CITY COUNCIL MEETING STAFF REPORT

NAME OF PROJECT: The Homestead Resort

AGENDA ITEM: Amendment of 2021 Master Plan

| DESIGN BY: PDB DRAWN BY: DAA | DATE: 29 JAN 2025 REV: | SHEET 1 |

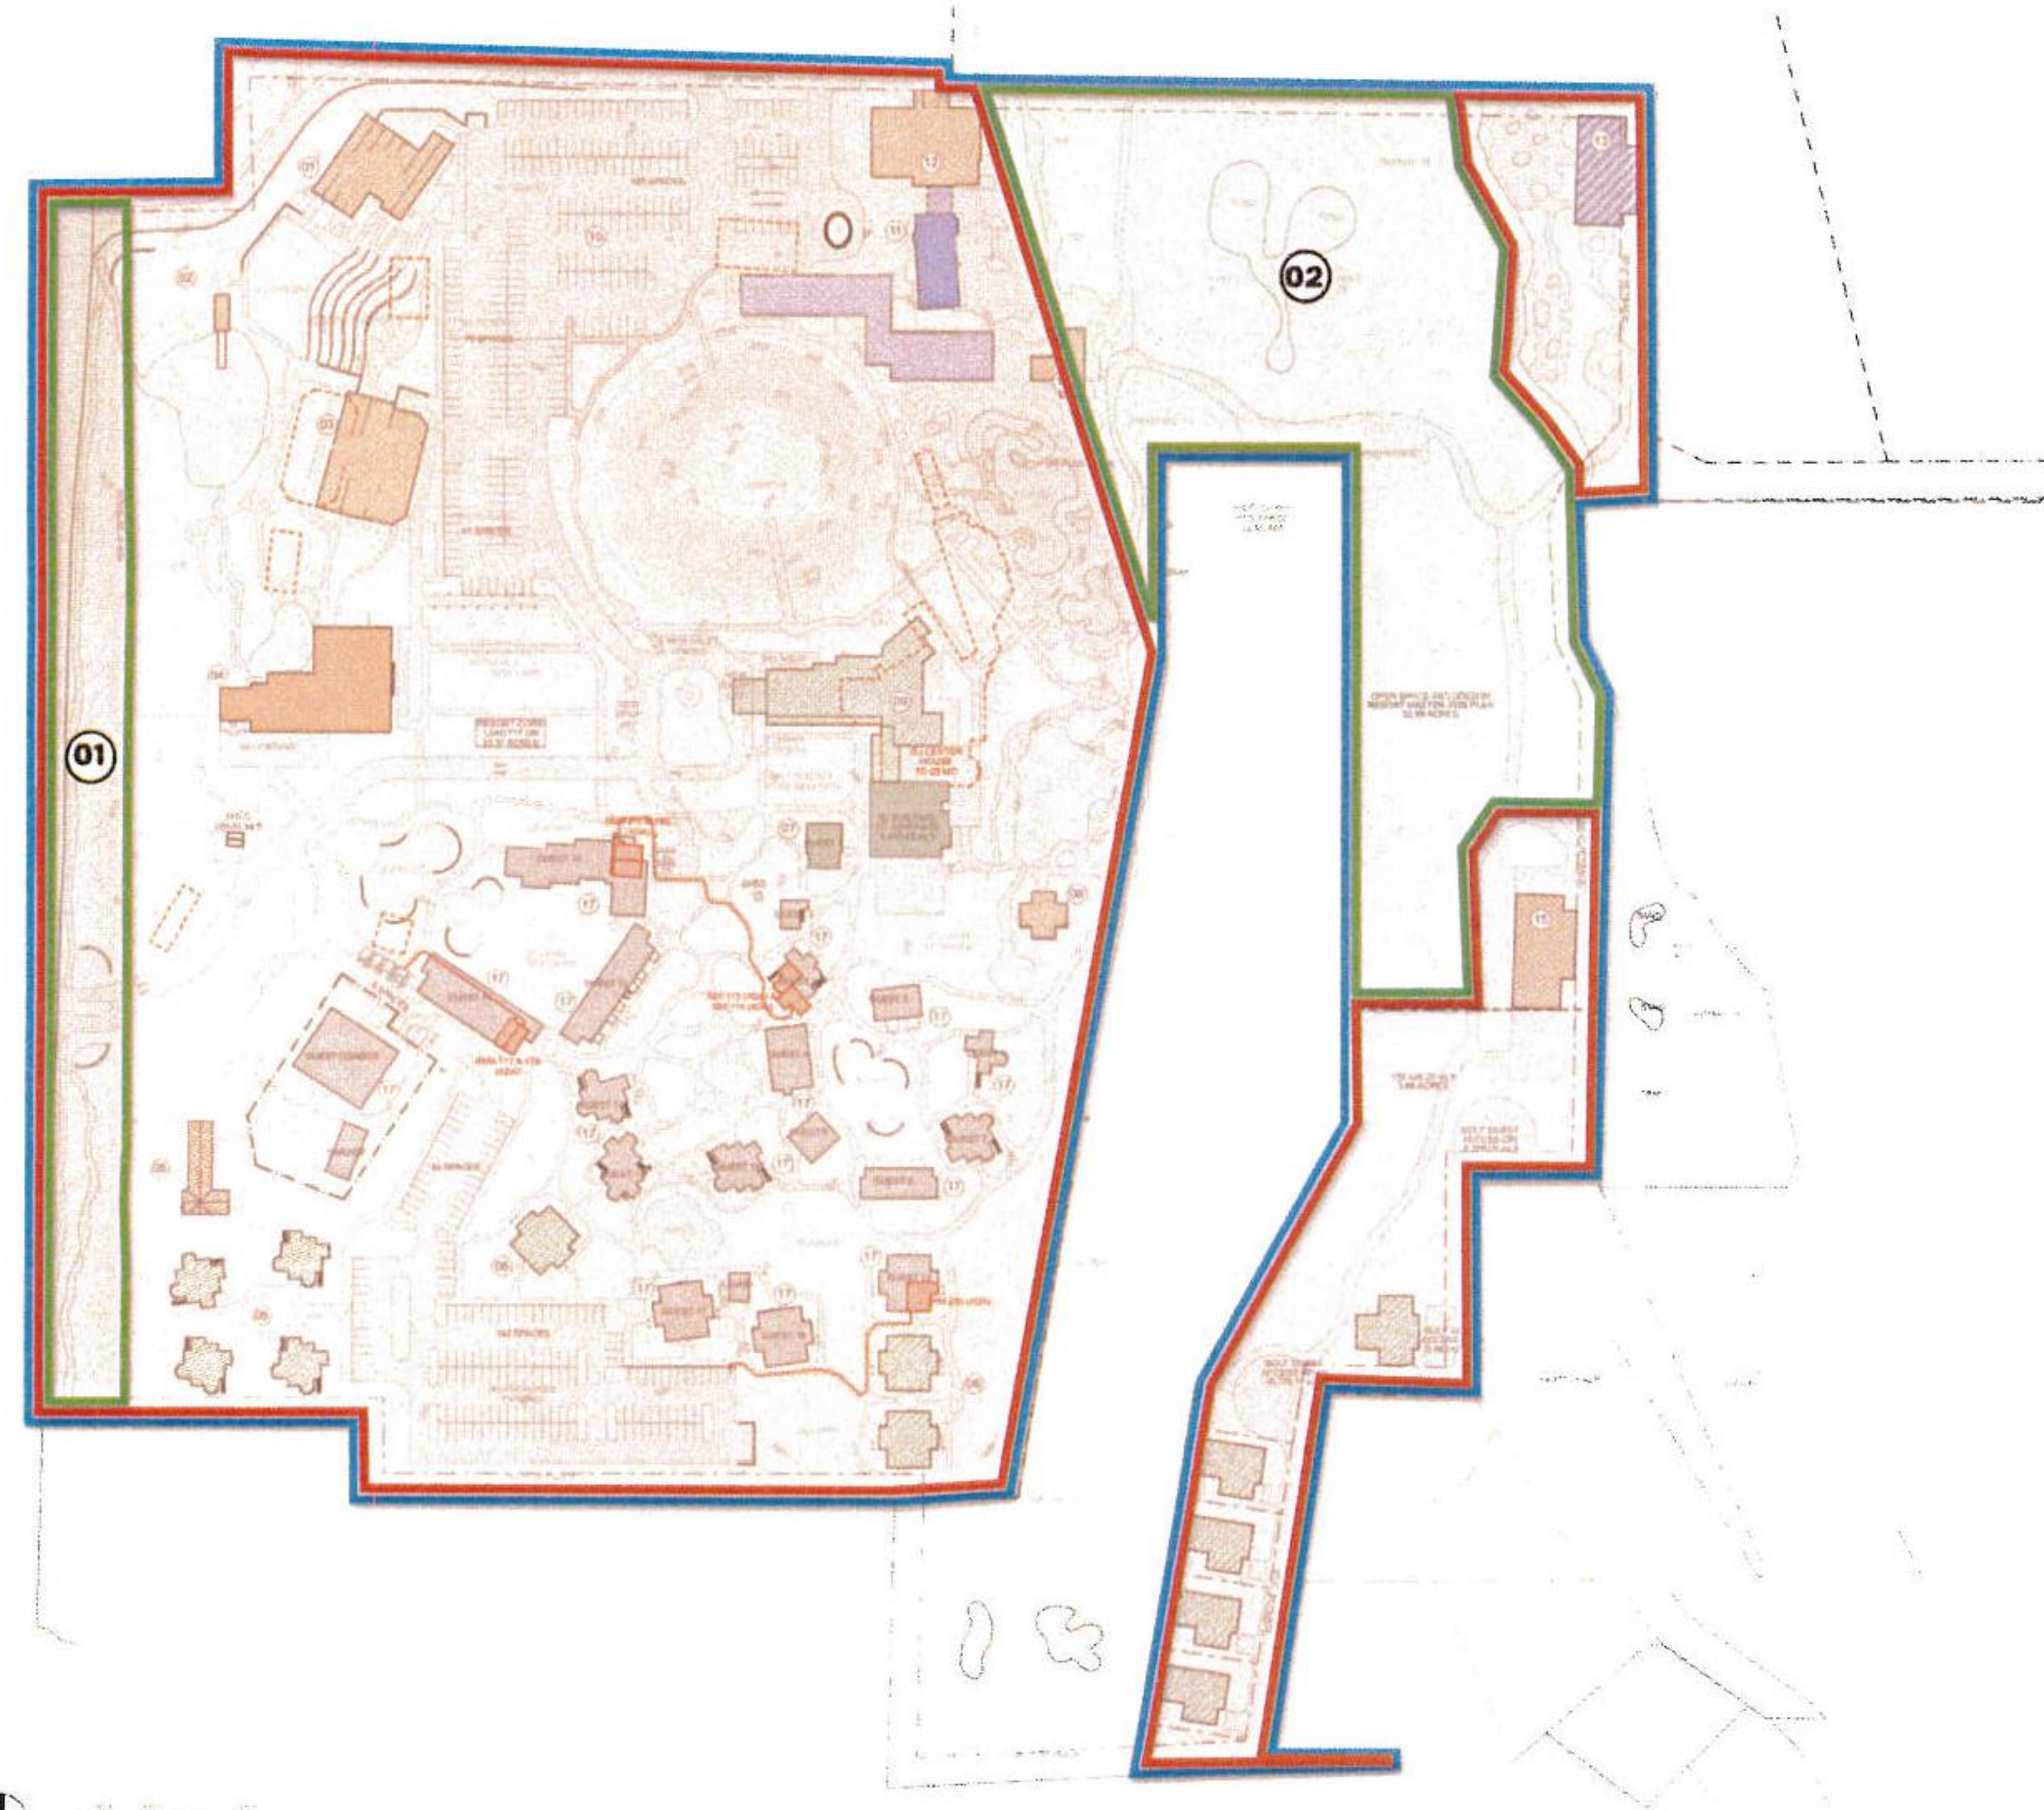
The proposed amendment to Exhibit C will adjust the location of, but not reduce, open space in the resort core. The purpose of this amendment is to move the location of the proposed maintenance building to an area that, according to the applicant, is less visible from neighboring properties and to resort guests. The resort core open space is 10.53 acres, and the proposed amendment would leave the acreage unchanged. The applicant states the following in the application:

This is a minor amendment to an Exhibit C – Resort Open Space in 2021 amendment. The maintenance building is proposed to be relocated into an area that will be less visible to neighbors and to resort guests. A swap of open space and resort developable area is needed for the new location. The total open space in the resort core remains 10.53 acres.
